Village of Skaneateles Pedestrian Safety and Access Study

Study Advisory Committee Meeting Notes

#### Study Advisory Committee Meeting 1

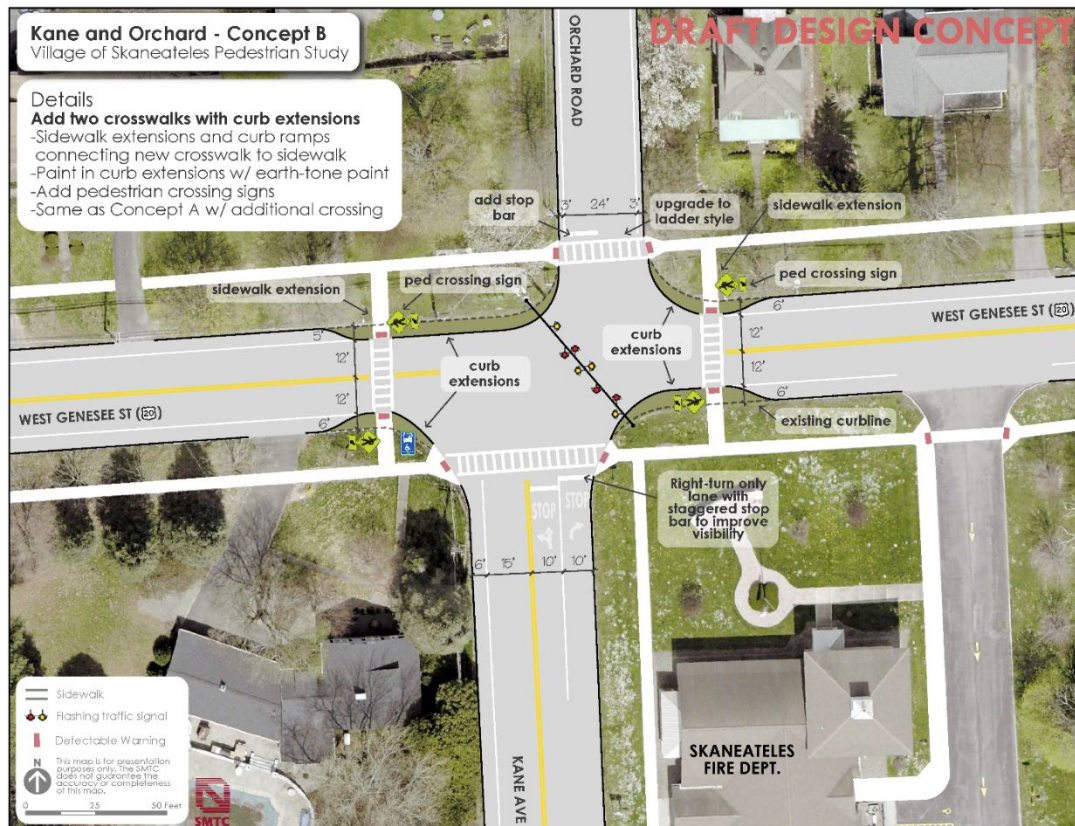
- **Mr. Bates:** A crosswalk by itself does not create a safeness for pedestrians. The layout also is a concern because it is close to a right turn. Same issue for Orchard. The offset overall is not good. If there is no ped concern they would hate for an issue to be created.
- **Mr. Cregg:** When sitting to make a left turn from Kane onto W Genesee in morning hours you are looking for a gap in traffic since there is nothing that pulses the gap. He agrees with Mr. Bates' comments about when cars are looking for a gap it creates another thing for cars to be concerned about.

Concept A – Add Curb Extensions

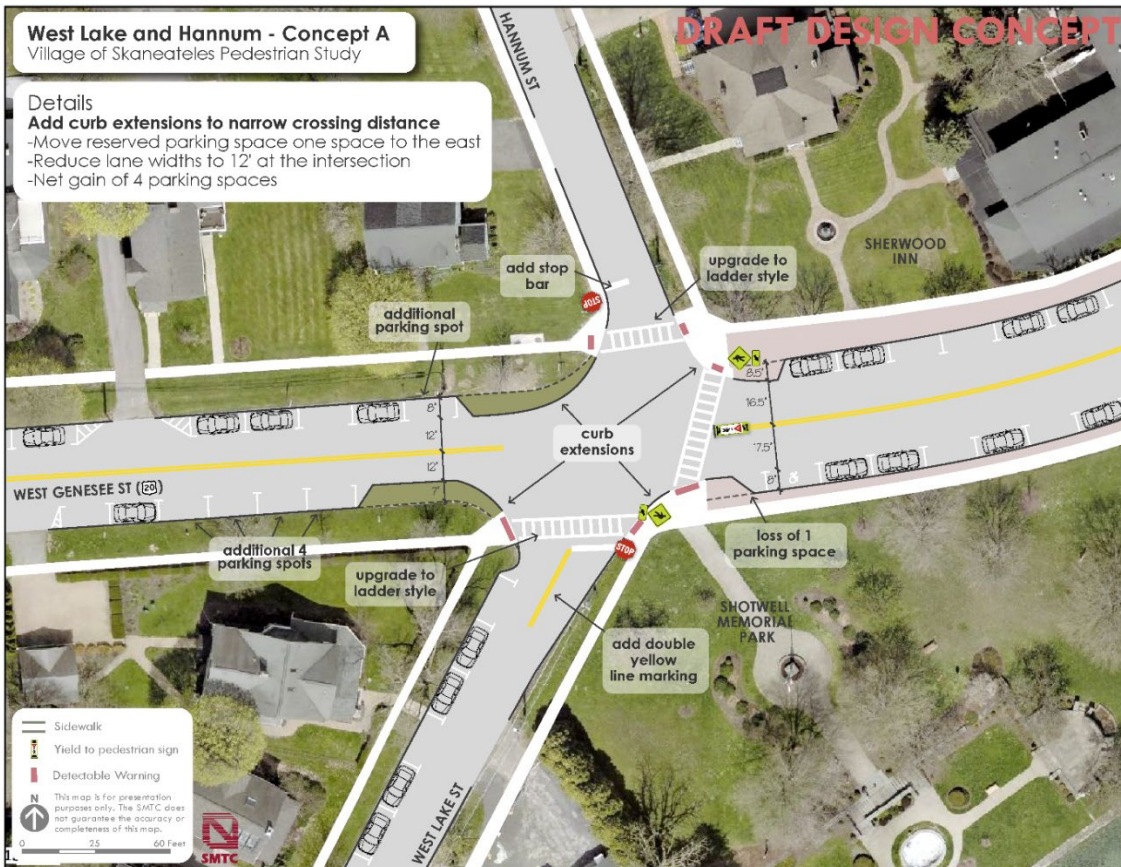
- **Scott:** Makes the most sense to him. Note: The yield to pedestrian's signs is only intended for mid-block crossings.

Concept B – Add Curb Extensions to Reduce Intersection Angles

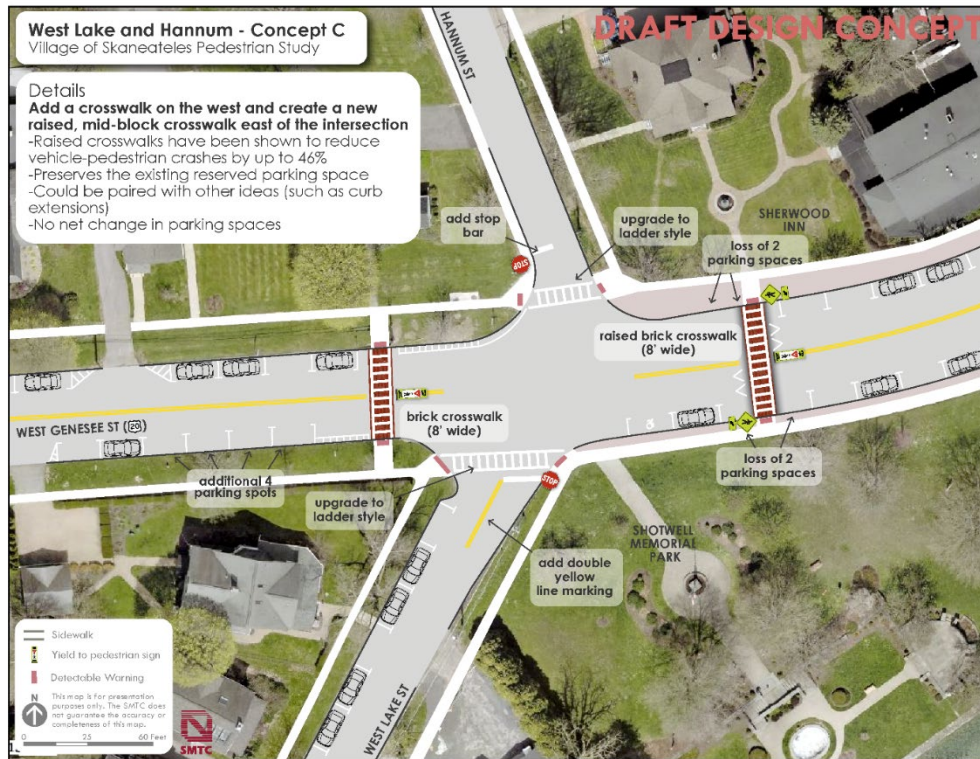
- **Mayor Sennett:** In general, the painted curb extension would be more palatable. Raised extensions might be problematic for their DPW due to the plow trucks possibly having an issue.
- **Scott:** Agrees with Mayor because of the tight radii.

- **Mr. Cregg:** Extra cross walk signage was added throughout the village. Scott said they had to do with the PSAP improvements and will hope to study data in future to see the affects.
- **Mr. Cregg:** Signs do better than pylons in road.

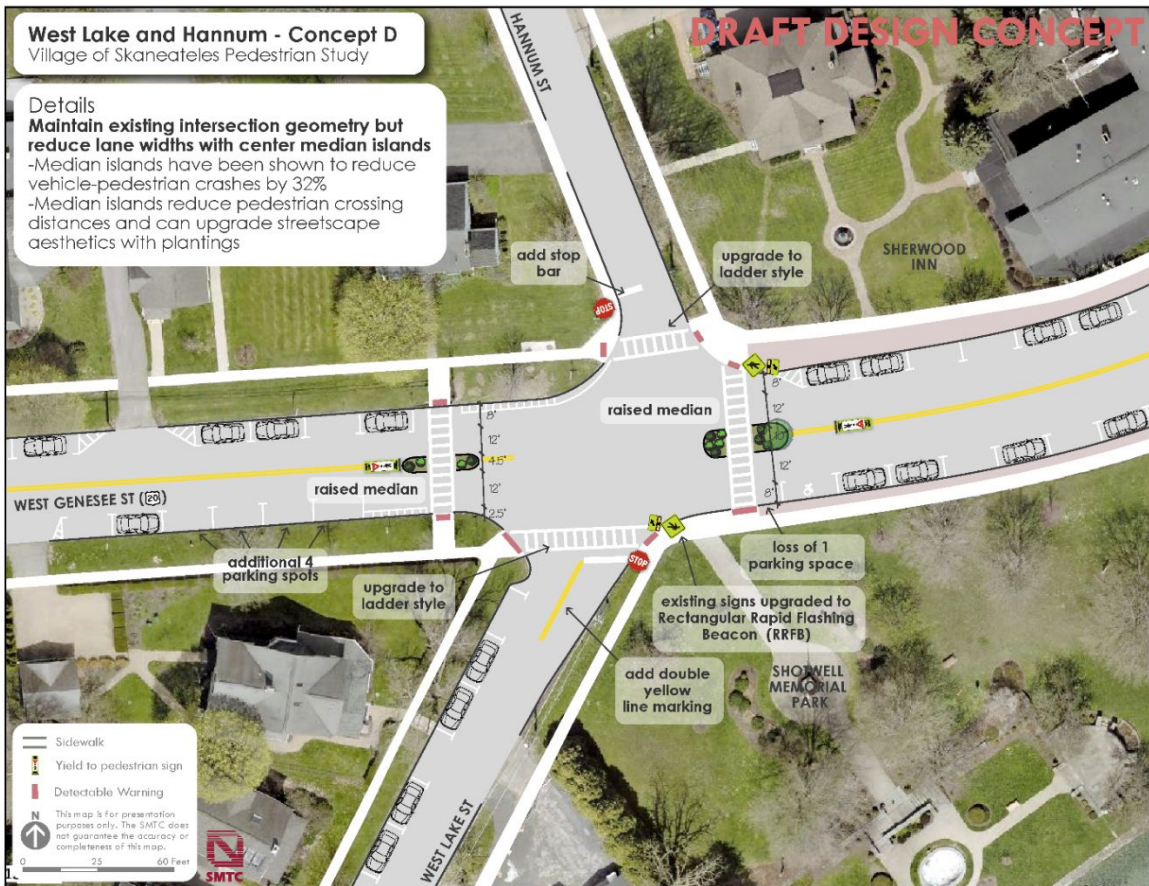
- **Mayor Sennett:** Concerned about raised crosswalks. The agricultural traffic needs to be taken into consideration and has concern about that. Concerned also about maintenance of raised crosswalk in snow conditions. More discussion about the painted-in extensions would be worthwhile.

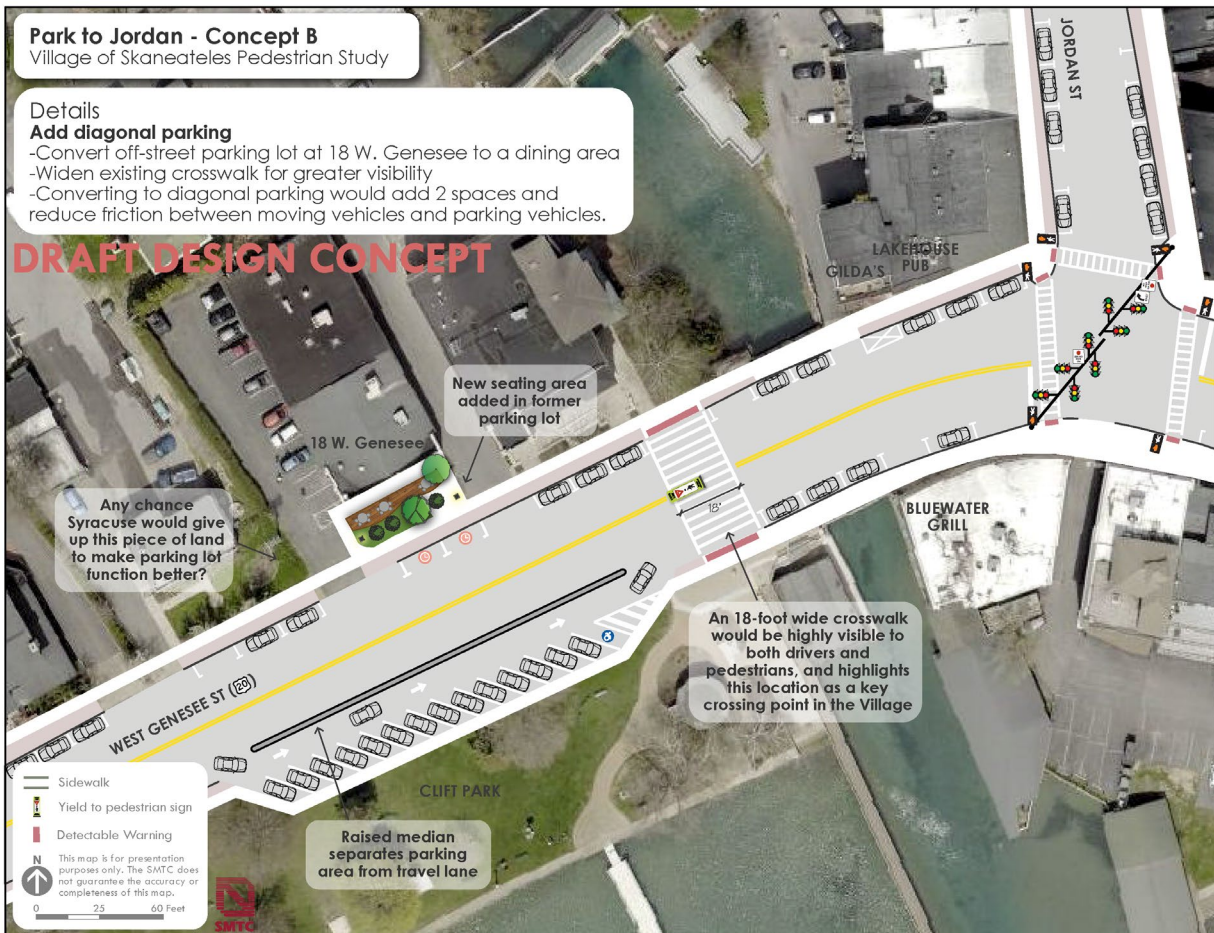
- **Mayor Sennett:** That building is a Pioneer Company property. They came to the Village some time ago and checked on easements. She suspects they will be redeveloping that site. They changed the street configuration in front of the post office already so she believes everything suggested could be moot.
- **Mr. Cregg:** Only location that has grab-and-go food. Agrees with Mayor Sennett about differing discussion of the proposed changes at the moment.
- **Mr. Goethe:** Input from the group would be good for whenever they do come through to the Planning Board stages. Board should be armed with some schematics.

### Concept B – Add Diagonal Parking

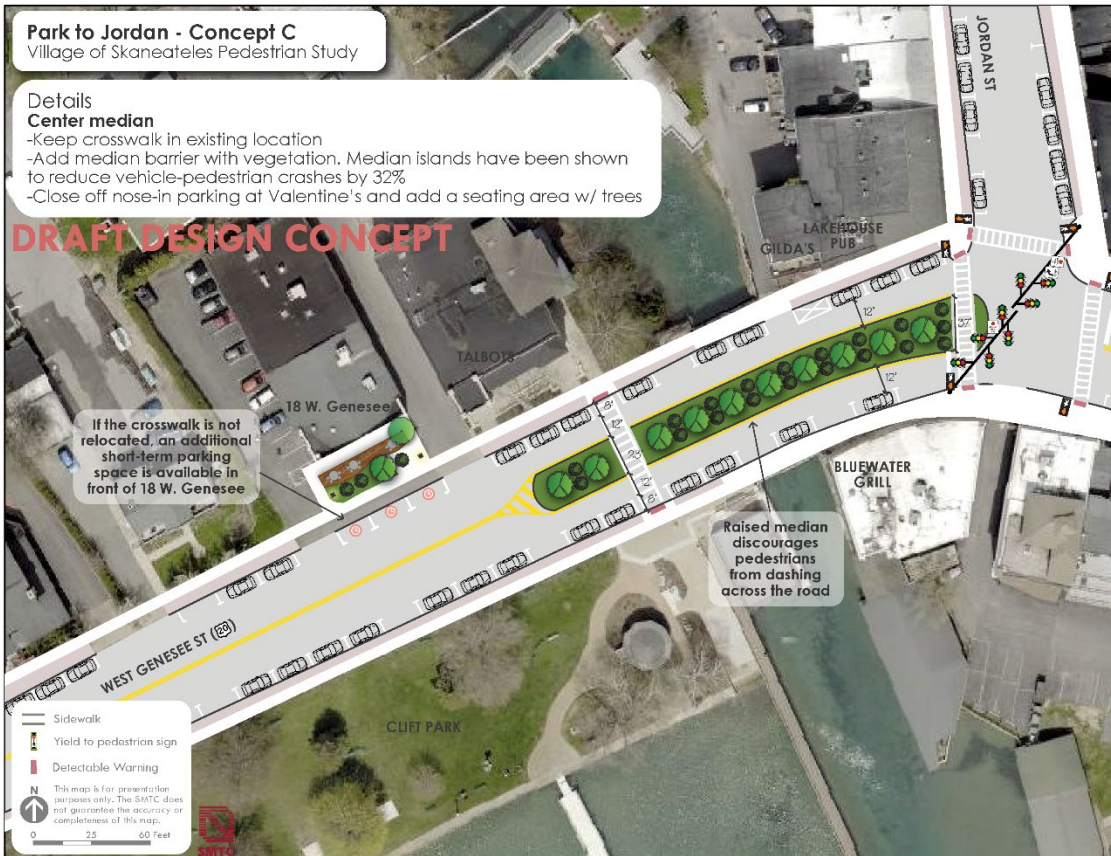
- **Mayor Sennett:** Do not show to the public the in-angle parking.
- **Mr. Cregg:** Why would you not encourage them to cross east of the current gazebo crosswalk? Crosswalk was where it was to service the dinner boats which is no longer accommodated there [Note: four boats continue to use this location]. Would like to push people more to the intersection to the east.
- **Mayor Sennett:** Have we looked at eliminating the crosswalk? Mr. Cregg would agree.
  - If that option is placed out there, she would be interested in that option and what people would say.
- **Mr. Goethe:** Believes the same as Mayor Sennett that eliminating the gazebo crosswalk option would be interesting.
- **Chief Bueler:** May get jay walkers if eliminated.

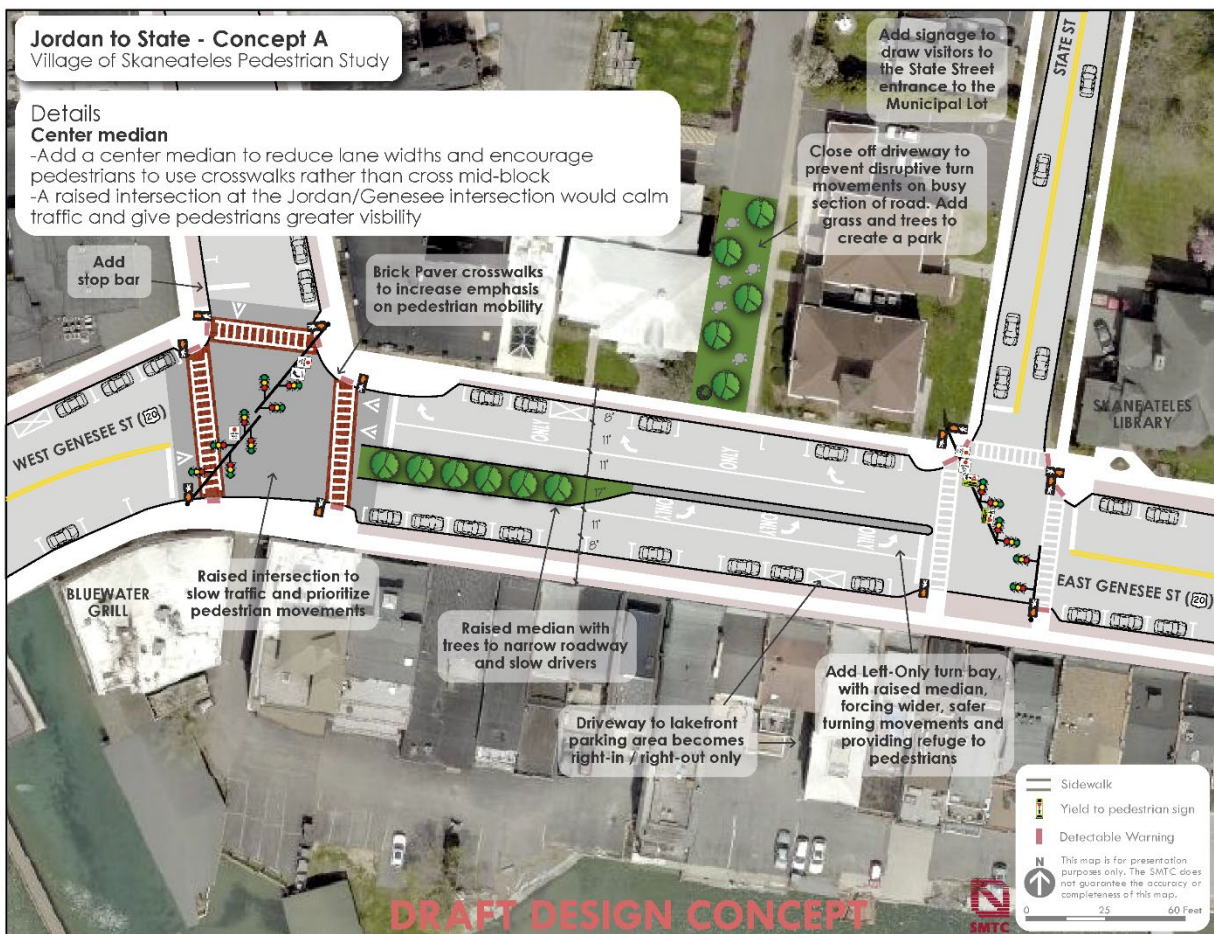
- **Mayor Sennett:** The movement of pedestrians around those crosswalks is an issue. Having people walk when cars are trying to turn right really jams things up. She is wondering if it is possible to have everyone walk at the same time. On Jordan you must sometimes wait three lights just to get on Genesee during the summer. Most of the week there are higher traffic issues.

- **Mr. Cregg:** Transformation of the village caused the village to be both a destination and increased local resident usage.
- **Mr. Bates:** With Synchro one thing to keep in mind is having two signals within close space and then when you throw in ped crossings it is even more an issue. Want to look at the queue lengths and the walk and don't walk times should be edited. Hard wire the two

- **Mayor Sennett:** How about all way walk time?
- **Scott:** Have one in Cortland but have gotten requests to take them out. Unless there is a ped safety concern they shy away from an all ped walk time.
- **Mayor Sennett:** Would like the State to look at the intersections of State and Jordan. To potentially send letter to Betsy (per Mr. Bates suggestion) requesting study of the intersections in more detail.
- **Scott:** Shy away from taking lanes away.
- **Mayor Sennett:** Placement of push buttons being set back is an issue. People do not see them.
- **Scott:** All push buttons are getting upgraded to audible as part of the PSAP.
- **Mayor Sennett:** Wants them closer to the crosswalks.

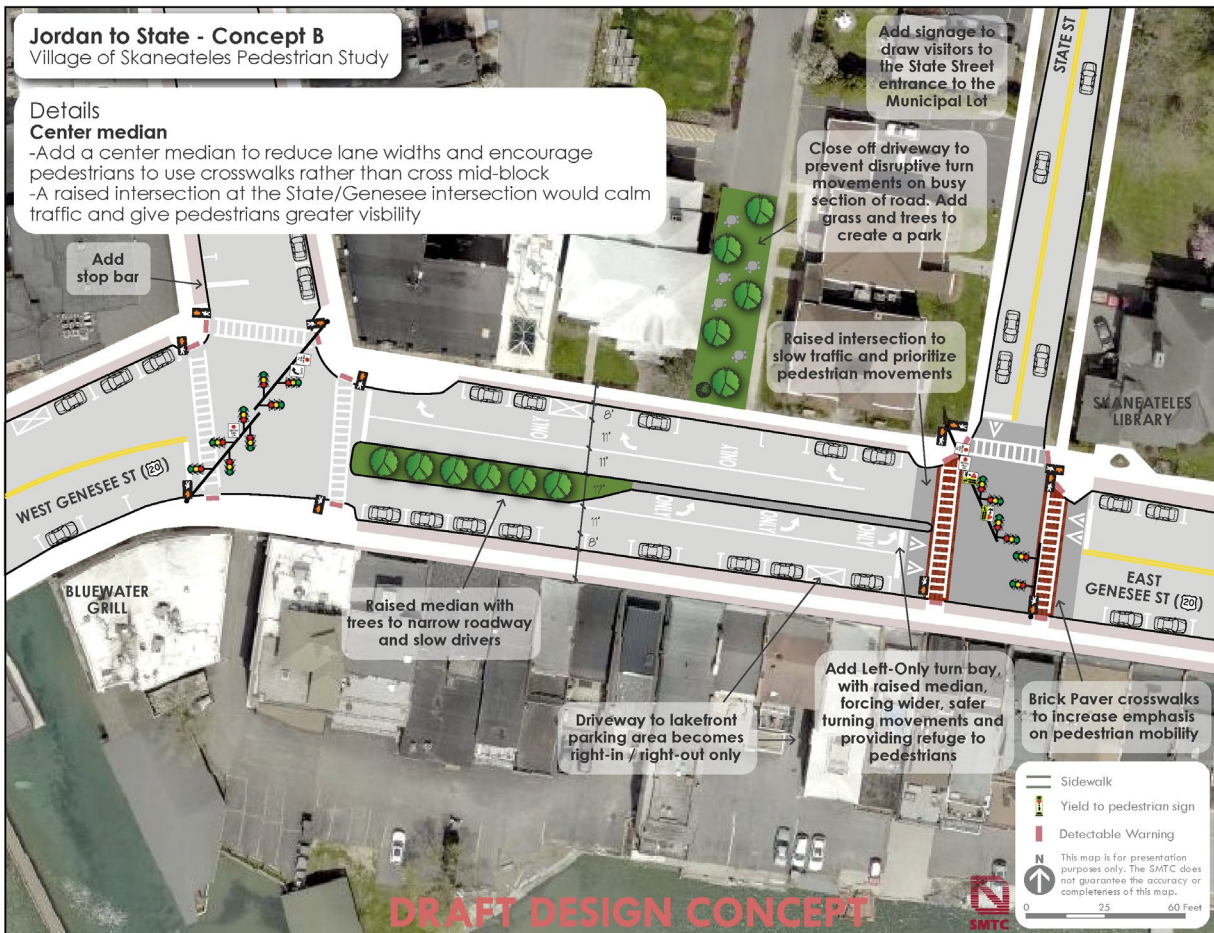
- **Mayor Sennett:** Set back on State Street stop bar she likes. Trucks going from Genesee St. to State Street do not have enough turn room
